**MEMORANDUM**

REVIEW TYPE: Preliminary and Site Plan Review
APPLYING FOR: RNC Zone; 36.00 Acres Property
 16 Single Family Dwelling Units/Lots
PROJECT NAME: Reserve at Ashton
CASE #: 1-02024 and 8-02005
REVIEW BASIS: Chapter 50, Subdivision Regulations and Section 59-C-9.575 and Section
 59-D-3 of the Zoning Ordinance

ZONE: Rural Neighborhood Cluster (RNC)
LOCATION: Located on Alexander Manor Drive, 1000 feet north of Ednor Road.
MASTER PLAN: Sandy Spring/Ashton
APPLICANT: Site Solutions, Inc.
FILING DATE: September 14, 2001
HEARING DATE: December 20, 2001

| PROJECT | LANDSCAPE & SITE LIGHTING PLAN |

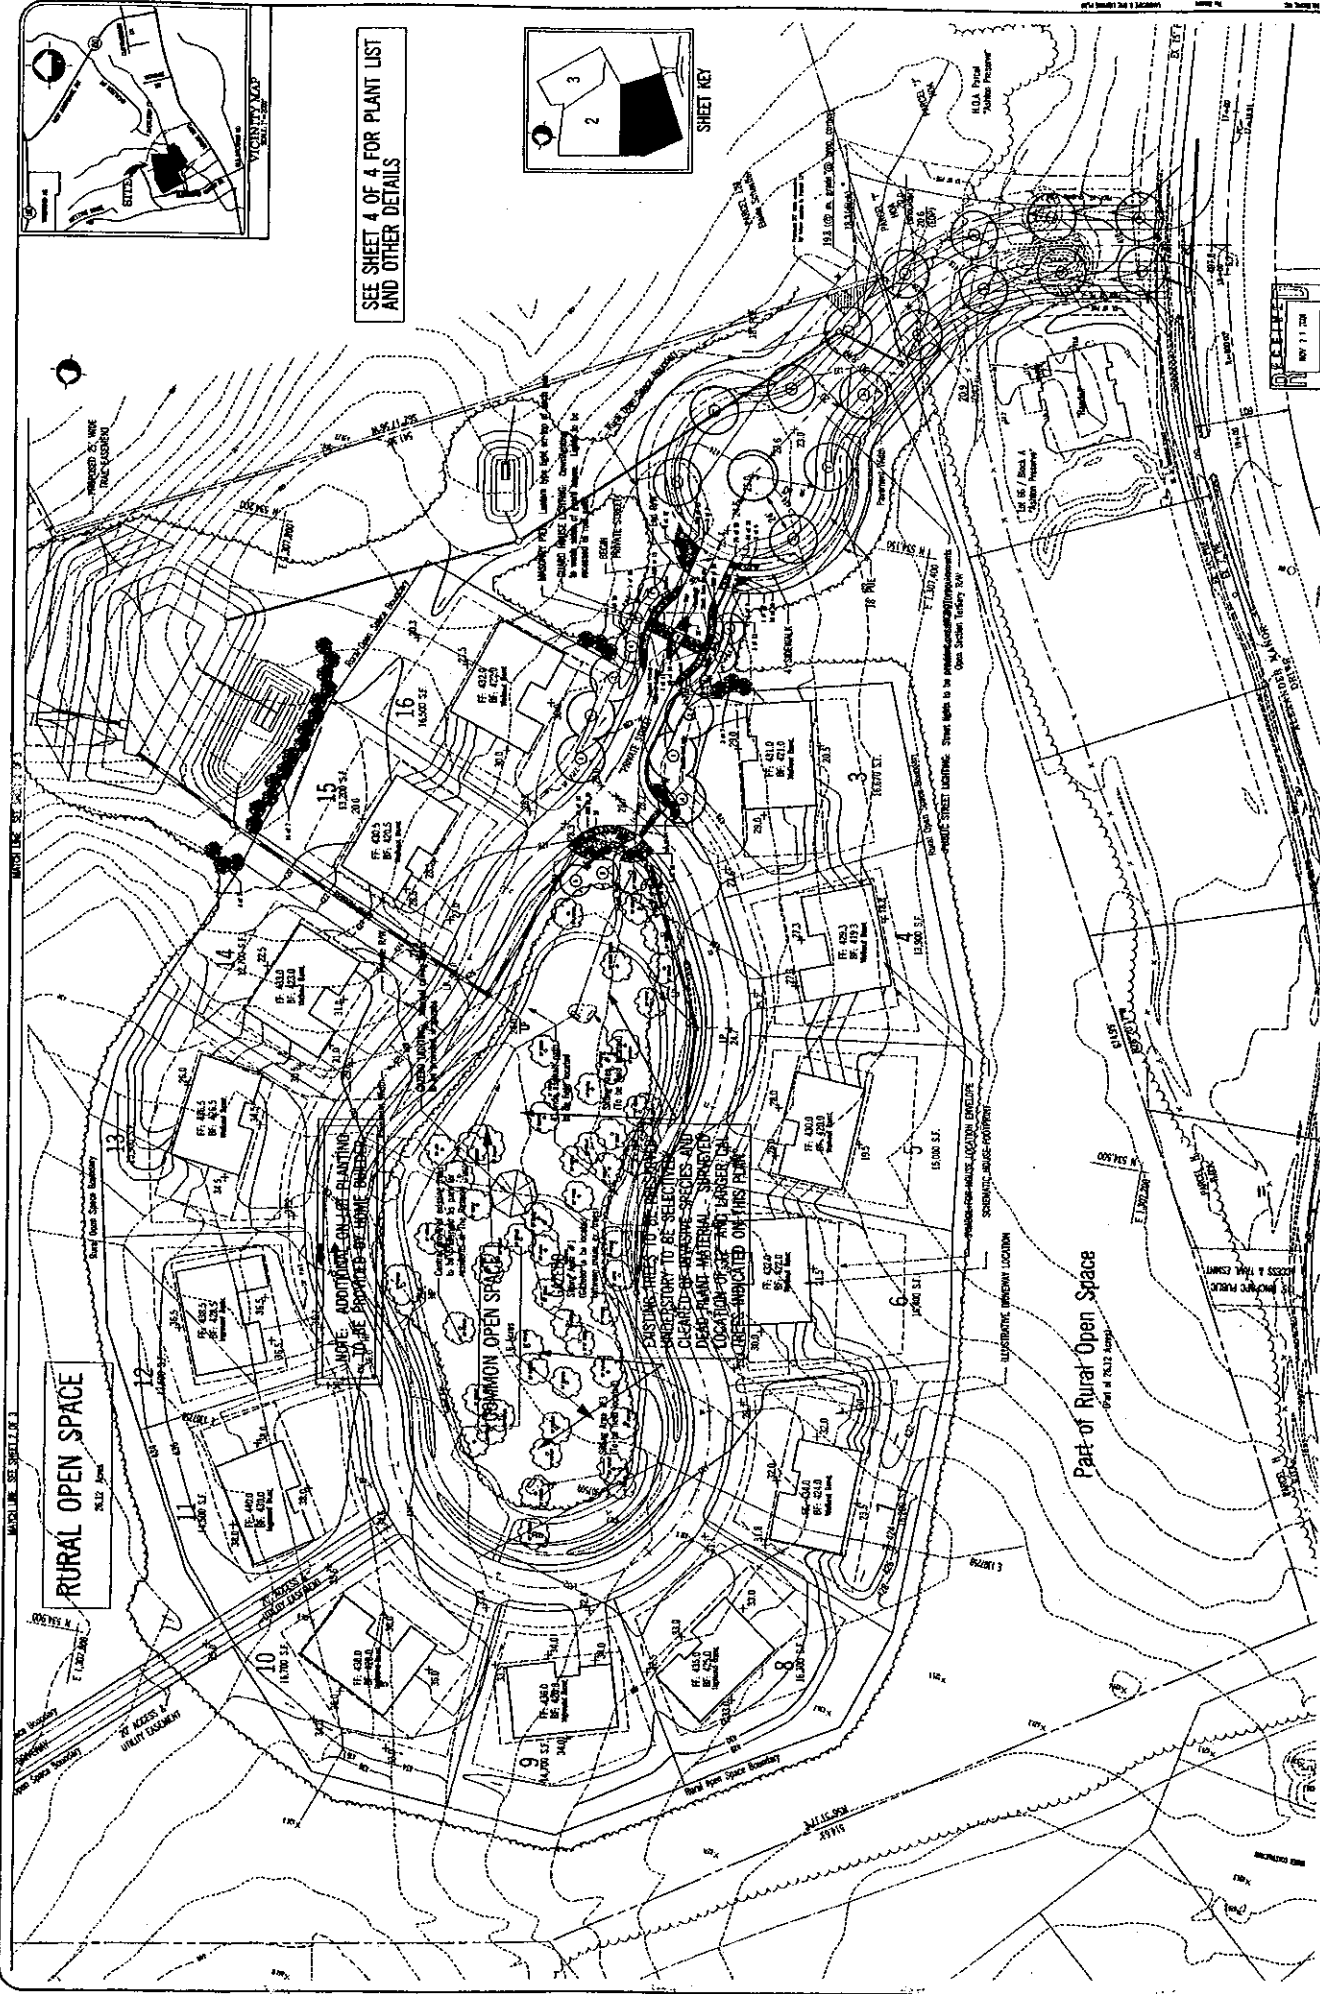
- i. Provide additional landscaping and screening in the rear of lot 16 to buffer the proposed stormwater management facility;
 - ii. Provide additional landscaping to screen the stormwater management facility from the public road;

- iii. With the exception of fencing in private back yards and around SWM facilities, any fencing to be provided on-site to be simple, split rail type or type acceptable to staff, to retain rural character. Applicant to provide details at

- iv. Provide a shade tree in the island in the public road cul-de-sac.
5. The services of a licensed arborist shall be retained to evaluate the appropriate measures necessary to ensure the survival of the large and specimen trees proposed to be preserved whose critical root zones will be impacted by construction, as shown on the Final Forest Conservation Plan.

Trail location

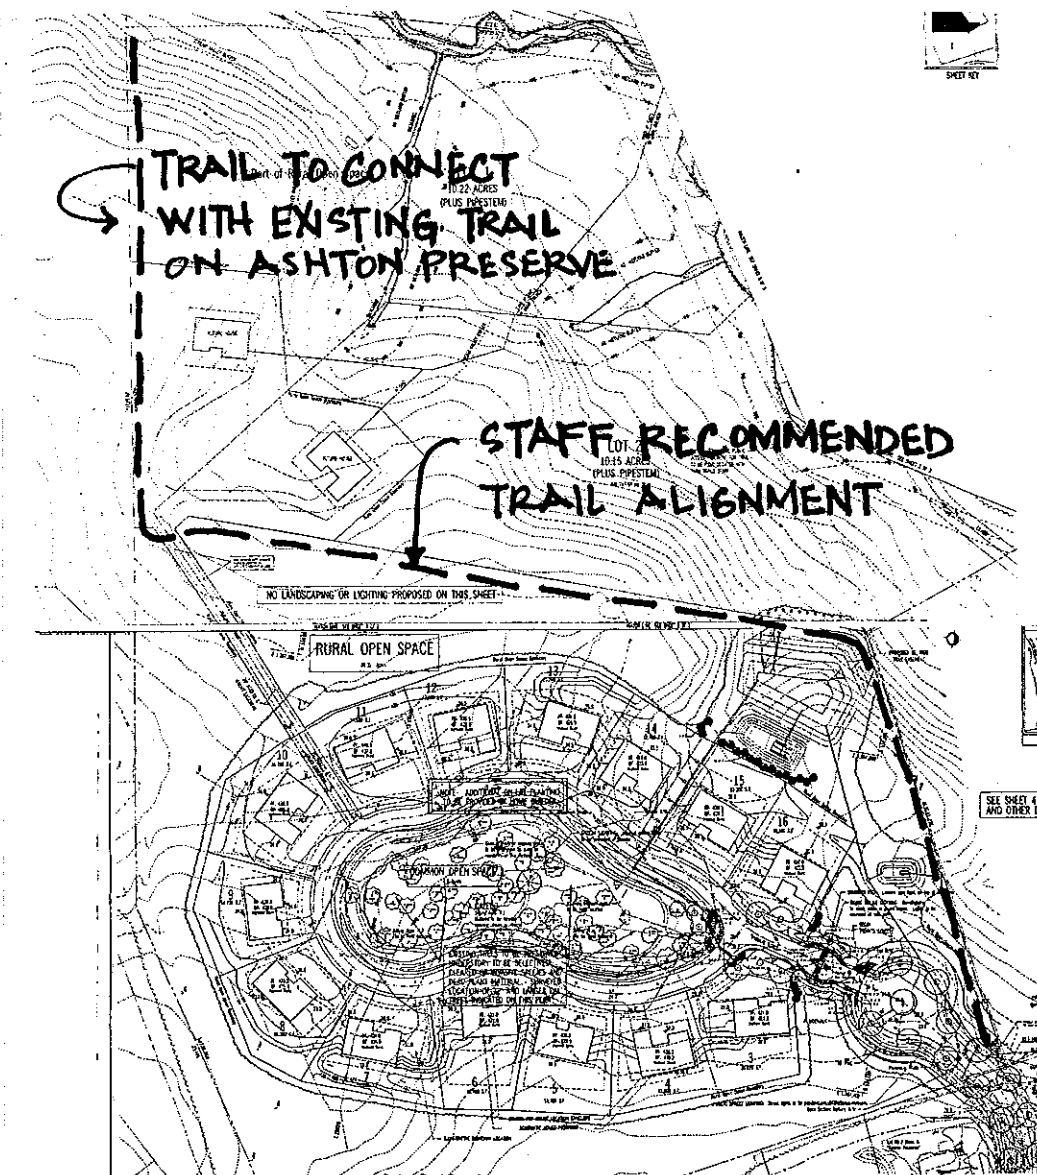
The subject property is adjacent to the master planned Rural Legacy Trail, via a neighborhood connection through the Ashton Preserve subdivision. It is very important that the new development connect with a significant open space amenity, such as the Rural Legacy Trail. Staff recommends that the proposed development contain a 20-foot wide public access easement, specifically to provide a future connection for pedestrians and equestrians to the Rural Legacy Trail. The proposed trail alignment supported by staff is shown on Exhibit 'A'. Staff recommends that the trail be accommodated within a 20-foot wide pedestrian-equestrian easement, shown as a separate rural open space parcel and shown on the record plat. The trail shall be constructed by the applicant and maintenance of the trail shall be provided by the HOA or other responsible entity, as provided in the HOA documents.

The applicant proposed a trail alignment different from Staff's recommended location. Staff believes that our alignment provides more direct access for future residents, opportunity for future connections to adjacent properties and provisions for easier maintenance responsibilities by the HOA or other entity.
